ASI NO. 14

TO : Conventional Builders
FROM : Studio JAED
DATE : April 11, 2019
PROJECT : DeIDOT Phase II Renovations

Changes to Ceiling Layout and Lighting at Greeting Area #1 and Media Room Storage Area.

SEATING AREA CEILING REVISION

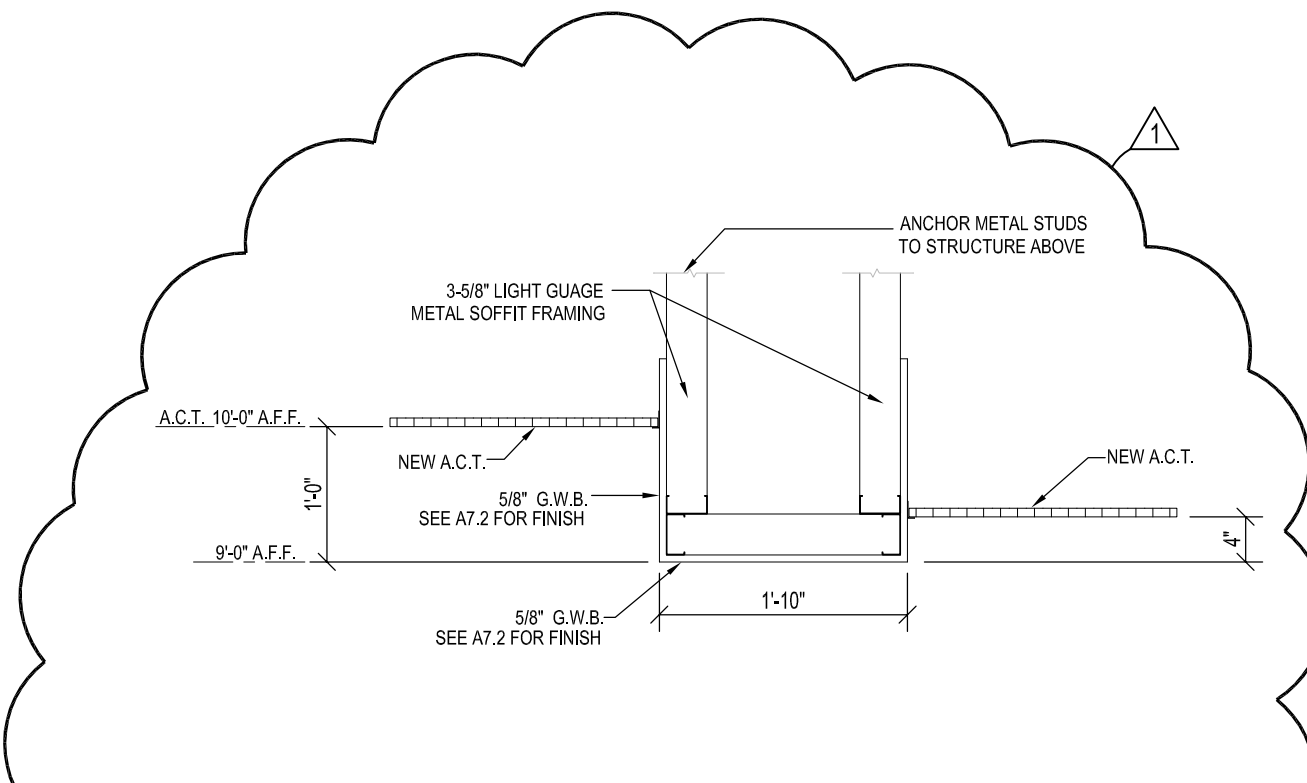
1. Drawing A3.3 – See attached Sketch SK-A.9.
 - a. Revise ceiling at Greeting Area #1 as shown.
 - b. Change ceiling height in Media Rm Storage Area to 9'-0" as shown.
2. Drawing A4.2 – See attached Sketch SK-A.10.
 - a. Add Soffit Detail 5/A4.2 for revised ceiling at Greeting Area #1.
3. Drawing E9.7 – See attached Sketch SK-E.9.
 - a. Revise lighting layout and quantity as shown.
